3.10.3 Level 02

4.0 SCALE & MASSING

Partial section through the east stand showing the overall building height

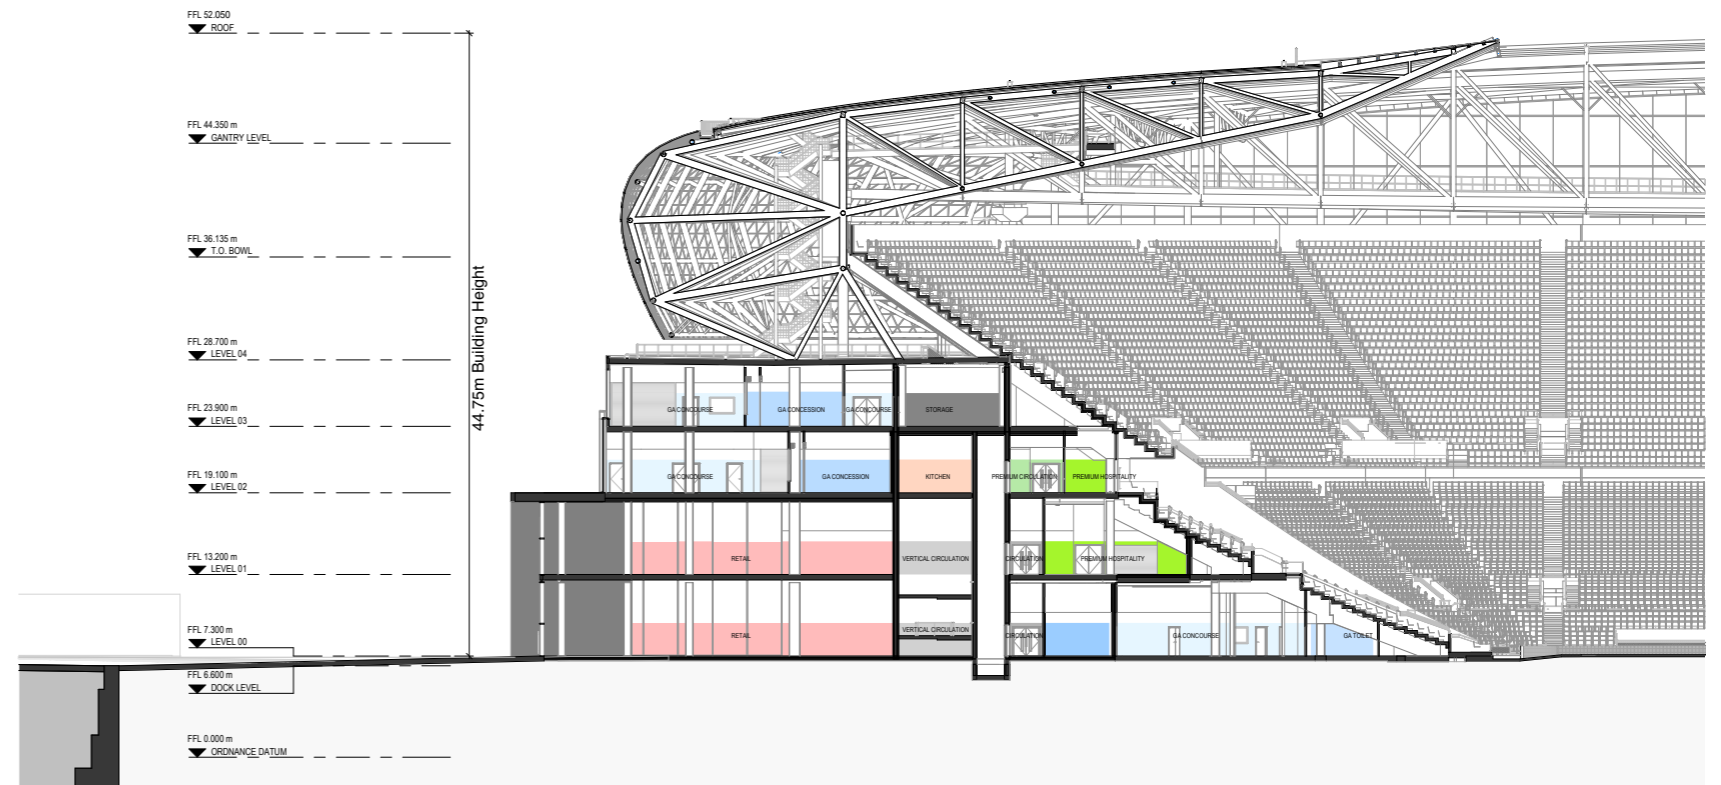
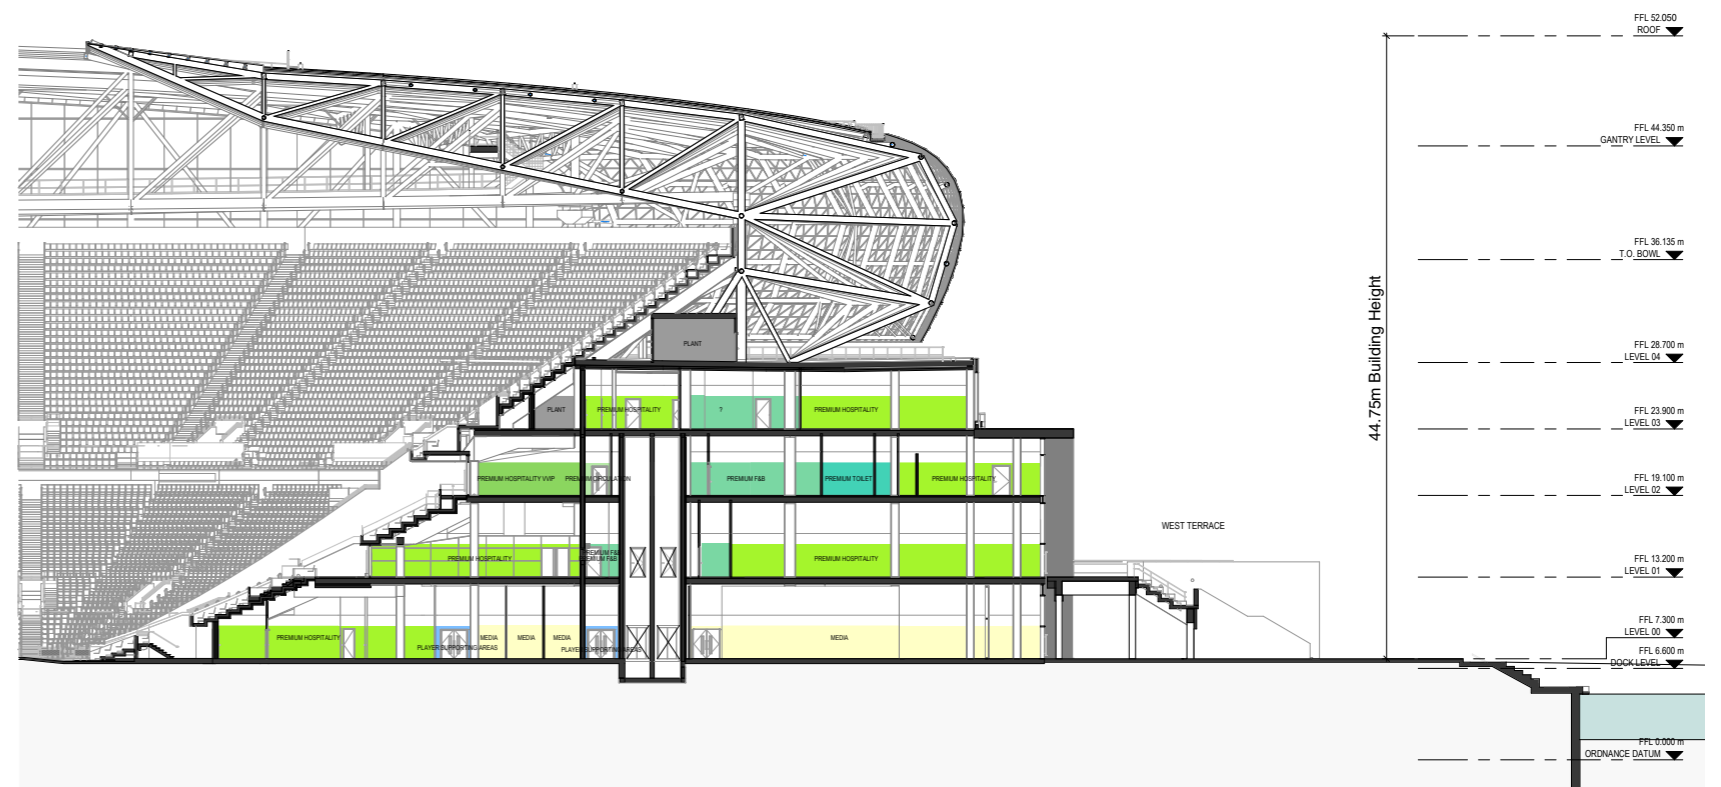
Due to the rationalisation of the roof structure as described in 4.1.1, the overall building height has been reduced. In the scheme submitted in December 2019 the maximum building height was 46.86m from the Level 00 floor finish level (FFL). The updated scheme has a maximum height of 44.75m from Level 00 FFL. This means that the building is categorised as a mid-rise building according to the LCC World Heritage Site Supplementary Planning Document (SPD).

It should be noted that the Level 00 FFL is set out at 7.30m above ordnance datum (AOD). This level has been set in accordance with the Environment Agency's request, following assessment of the flood risk at the site. Therefore the overall building height is a maximum of 52.05m when measure from AOD.

The south facade in the scheme submitted in December 2019

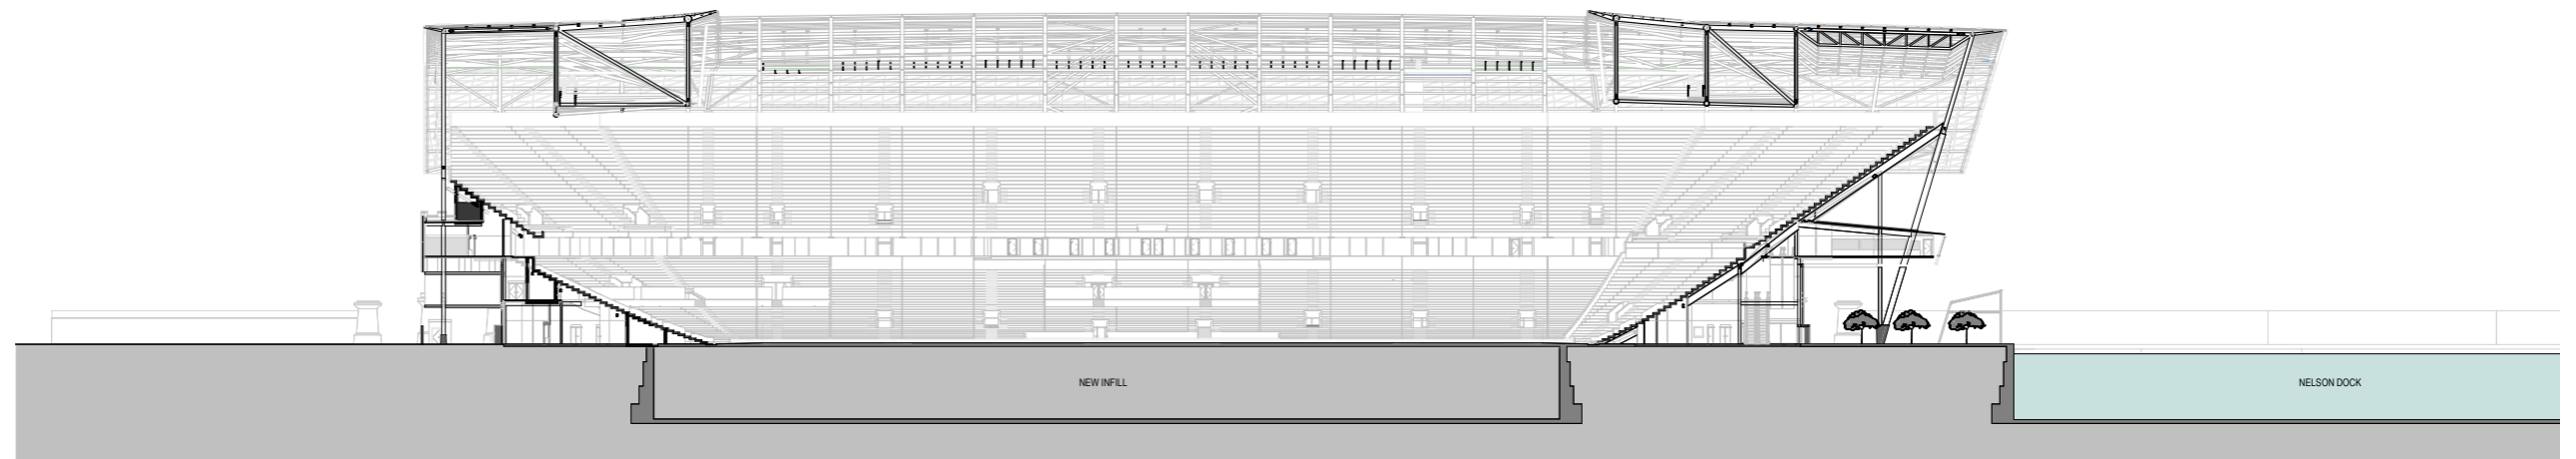
The overall concept of a brick box base that is in keeping with the warehouse typology of the Stanley Dock Conservation Area is unchanged from the scheme submitted in December 2019. Since the MSCP has been omitted from the scheme the building massing has changed, and the brick base is now a symmetrical form, with the barrel roof centred above it. This is particularly visible when viewed from the adjacent Nelson Dock, to the south of the site, where the full south elevation can be seen. Please refer to the comparison images on the next page which illustrate how the massing has changed.

The brick piers with four sizes, as per the scheme submitted in December 2019

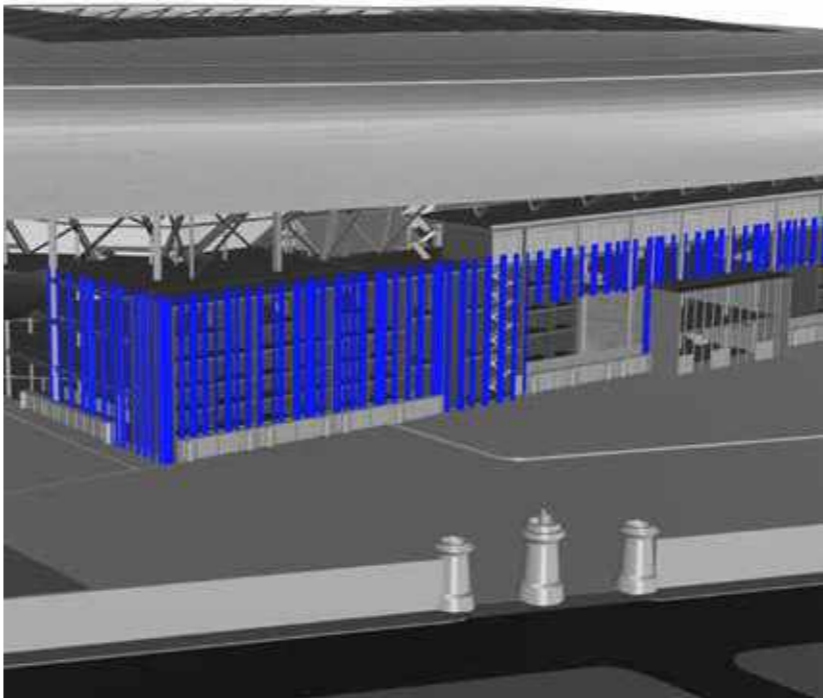
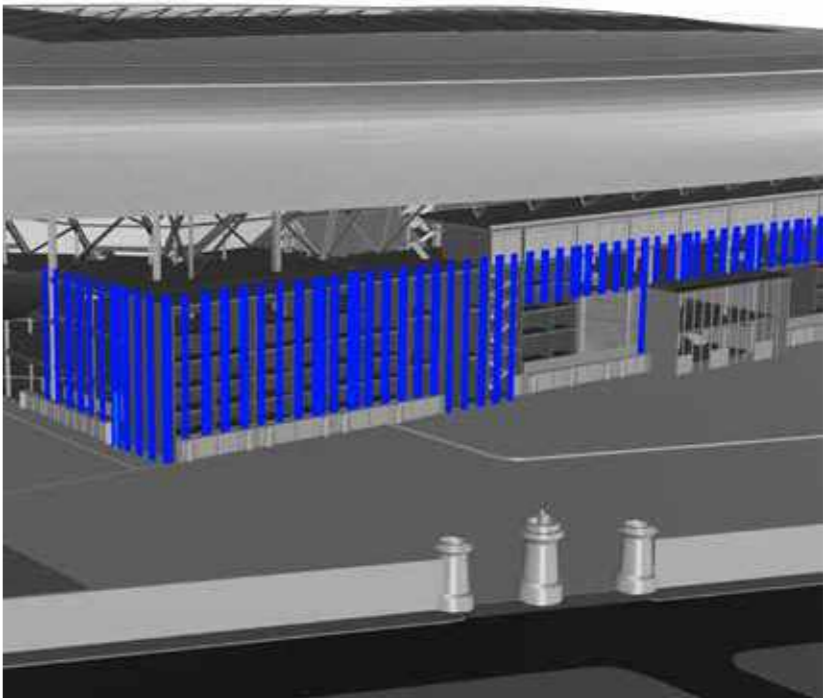
Previously the facade was formed with four different pier width dimensions. However, the smallest pier size was only 440mm, or two bricks wide. The initial Places Matter Review held in December 2019 prompted the rationalisation of the facade to bring it closer to the warehouse typology concept. On review, it was felt that the narrow pier was too “fragile” for the scale and context of the building. As such, the facade has been developed so that the smallest size of pier is omitted, but the overall percentage of the facade that is brick is maintained at circa 50%.

The result is a more robust and simplified facade. The updates to the brick facade have been viewed positively by the Case Officers from both LCC and HE and were praised by the Places Matter Panel at the review in May 2020. The diagrams opposite illustrate the difference between the previously submitted scheme and the updated proposal. The visualisation opposite shows the updated scheme.

The east facade and glazed portal in the scheme submitted in December 2019

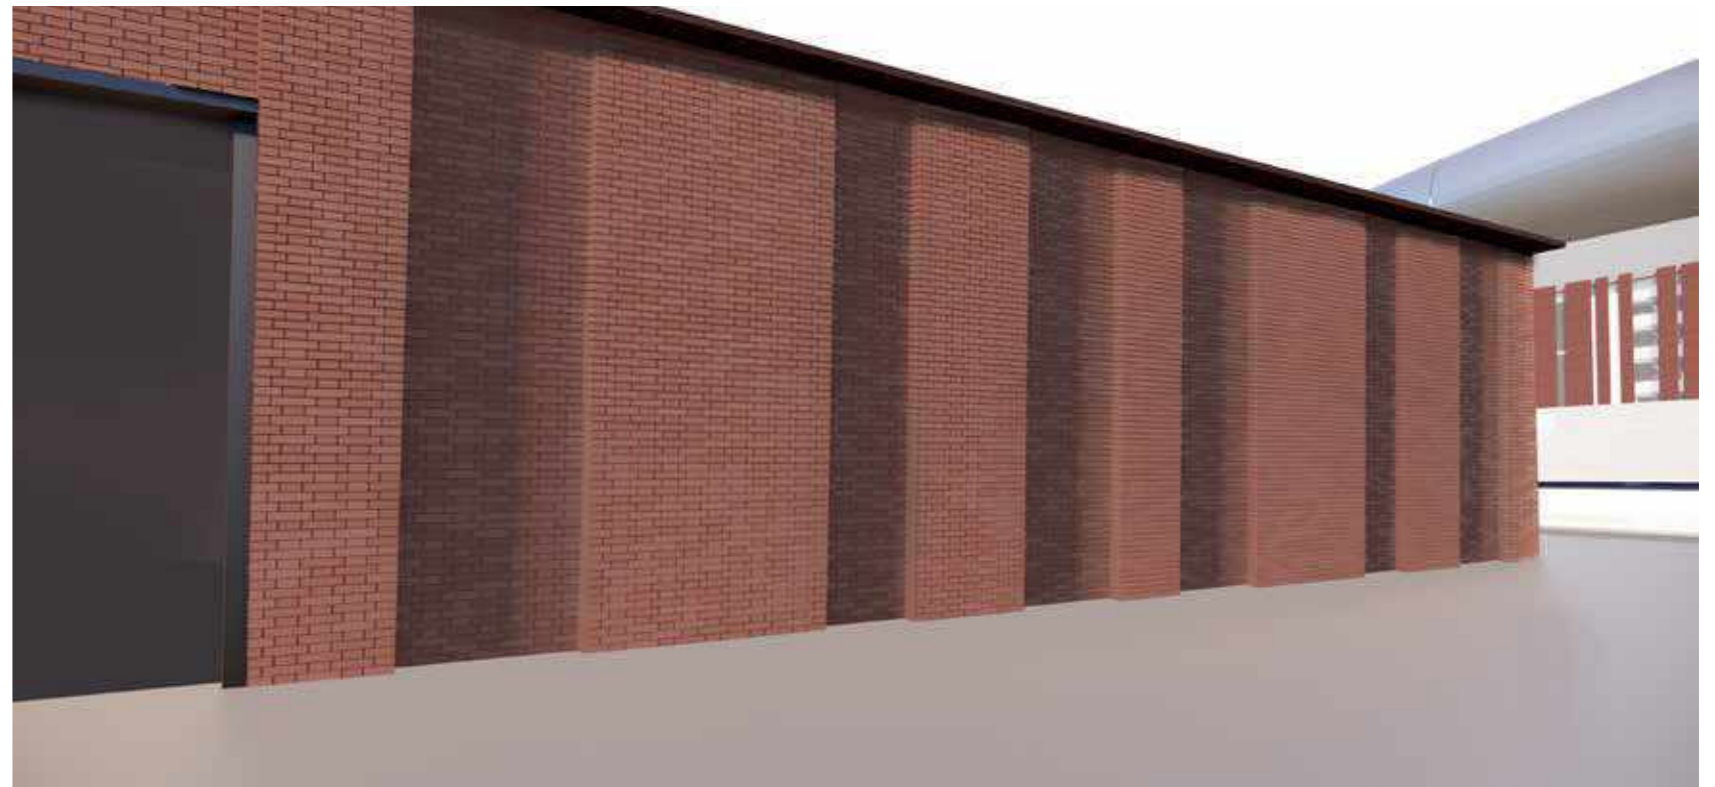
The large East Portal has been developed as part of the overall revisions to the facade and its simplification. In the updated proposal, the openings that were either side of the portal have been enclosed. This has several benefits:

- There is a greater extent of brick in the east facade, strengthening the brick base concept and the legibility of the truss pattern
- The portal stands out from the brick piers as there is greater contrast between the red brick and black metal, highlighting this central feature
- The General Admission concourses and circulation areas are more enclosed, providing better weather protection and a safer internal environment
